ADDENDUM #1

May 28, 2010

Re: Harrisburg Area Community College
Lancaster Campus Nursing Lab Renovations – M204 & M208
Solicitation #10-48

From: Eastern pcm, LLC
Construction Manager – HACC
645 N. 12th Street, Suite 200
Lemoyne, PA 17043

CURTAIN & IV TRACK INSTALLATION PLAN

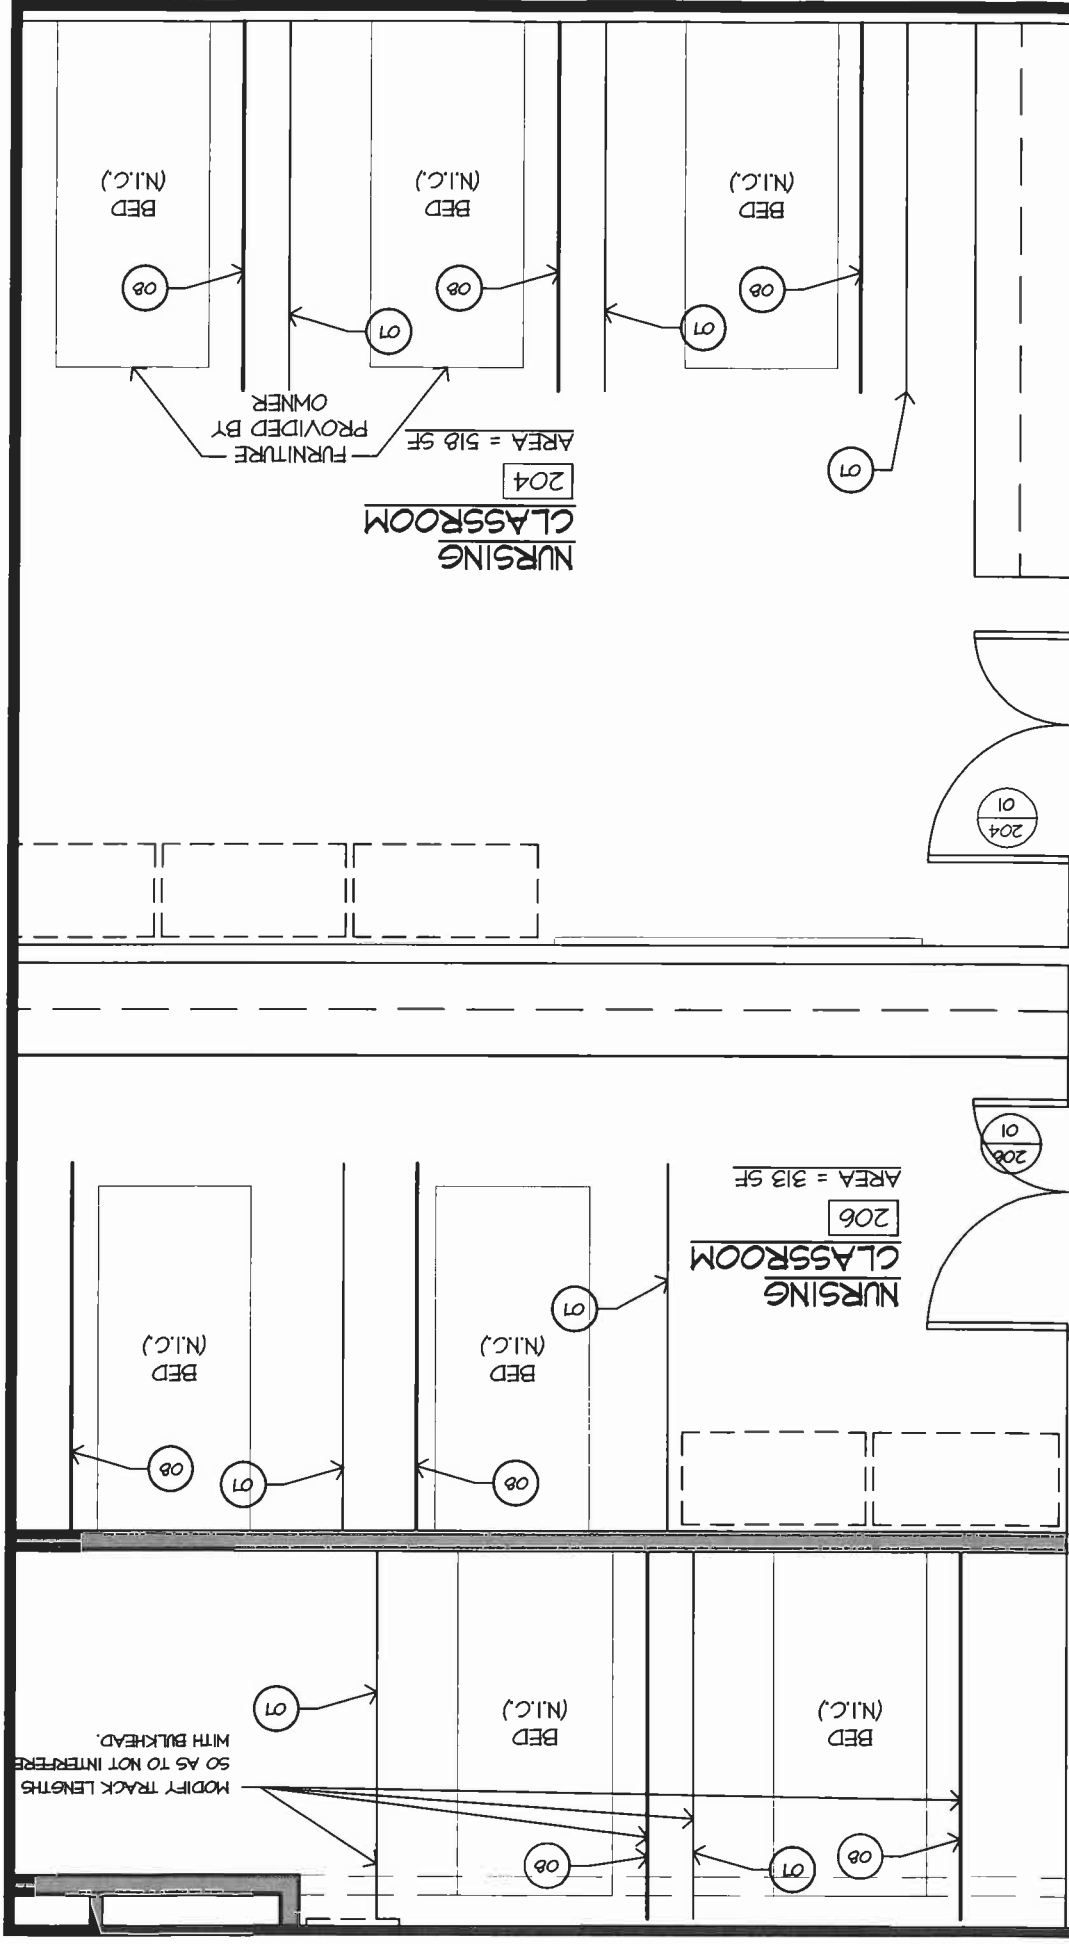
1. Refer to 02/A.1, Floor Plan: ADD the attached SK-1 drawing revisions.

ADD the following Construction Key Note in reference to the added SK-1:

"08 Install an I.V. Track Assembly manufactured by Automatic Devices Company, Allentown, PA including the following: (1) 8' length 1100IV Track Channel, (4) 1178 Ceiling Clips, (1) 1109IV End Stop, (1) Removable End Stop, (1) 1185 IV Carrier, and (1) 1187 Adjustable Pendant."

PARTIAL FLOOR PLAN

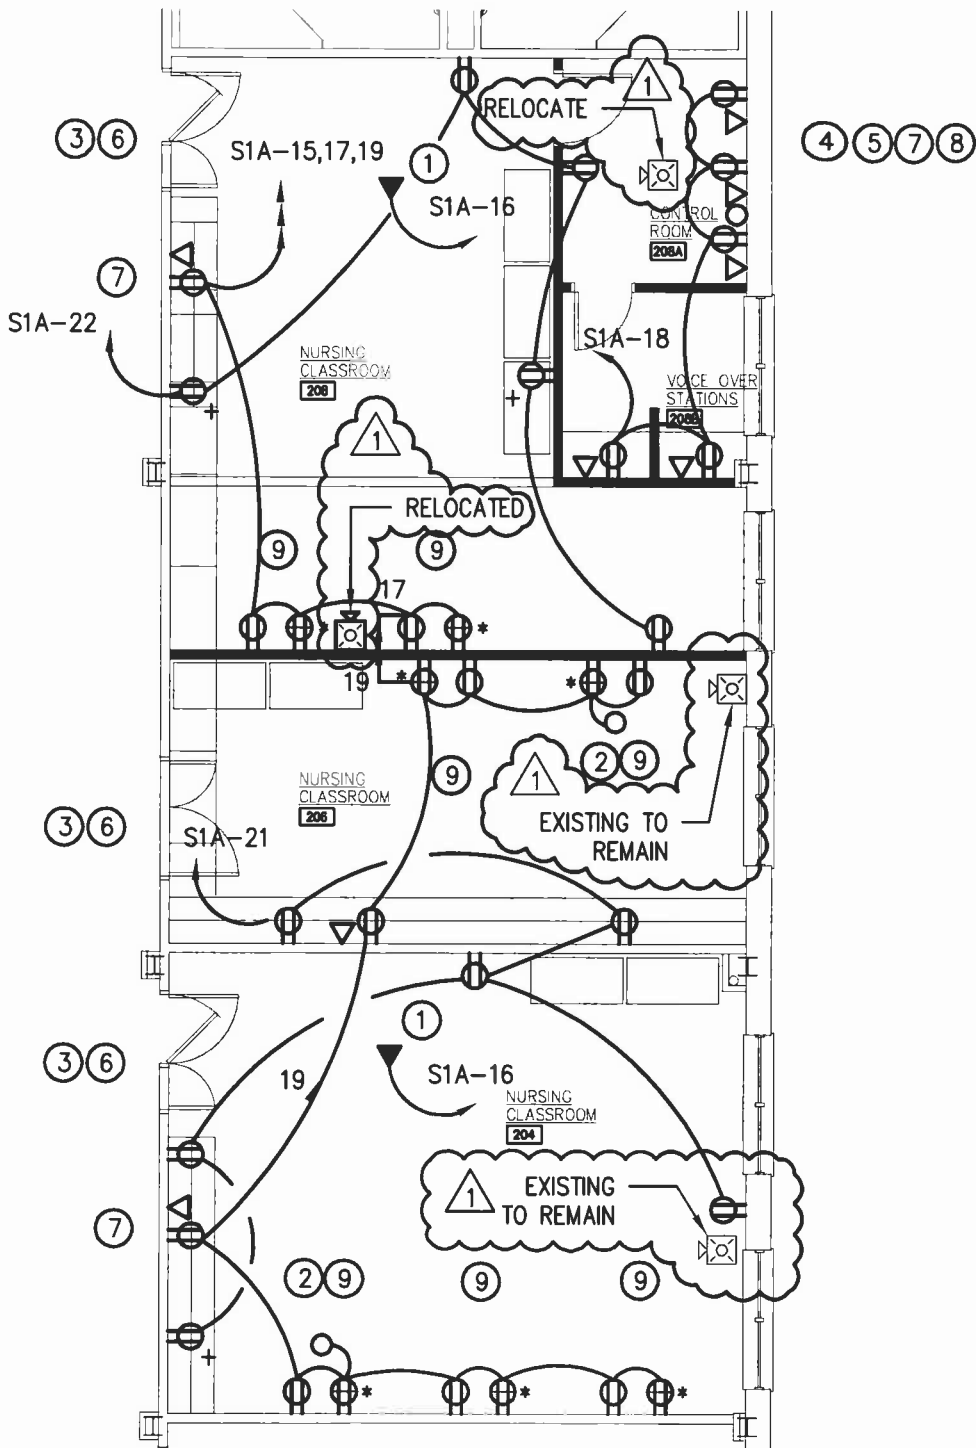
1. Refer to 2/E.1 Second Floor Plan – Power - ADD the attached SKE-1.1 Partial Floor Plan, 1/E1.1
2. Refer to 2/E.1 Second Floor Plan – Power, Notes: ADD the following Note:
 8. Existing Fire Alarm notification appliances shall remain. Relocate device in room 208 as shown on the plan. See sketch SKE-1.1
